Landscape Observations for 2024/0447/01/DET

Date 13 February 2025

Proposal: Erection of Battery Energy Storage facility with associated plant and equipment and supporting works including installation of retaining walls, boundary treatment, drainage and landscaping and relocation of substation following demolition of existing buildings on site.

Fig5 358 mesh potential alternative to palisade fencing

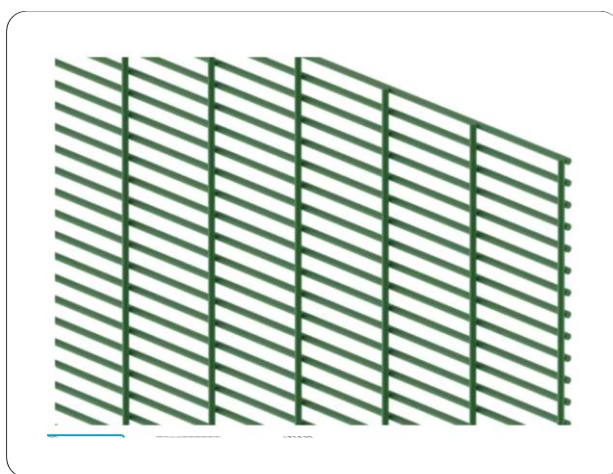
The green palisade security fence indicated on the drawings is not appropriate for the setting. If a high security fence is required, a 358 'prison mesh' type fence may be less intrusive. The fencing will need supplementing with soft landscaping, but the detail provided for a green boundary appears impractical, particularly as the ground conditions are not detailed. The height of the screen must have potential to grow to a height that breaks the skyline above the overhead plant

Fig 6 Areas (highlighted green) considered essential for landscape screening using trees and shrubs (including evergreen species)

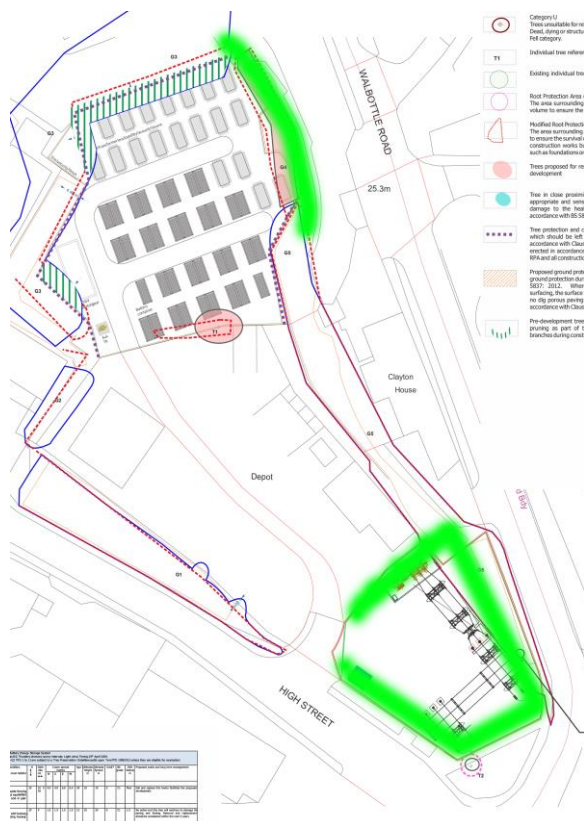
A Landscape scheme is required to help integrate the development into its setting and to reduce the impact on the neighbourhood (see fig 6). It is considered essential to provide a strong landscape buffer of trees and shrubs along the boundaries indicated in Green below.
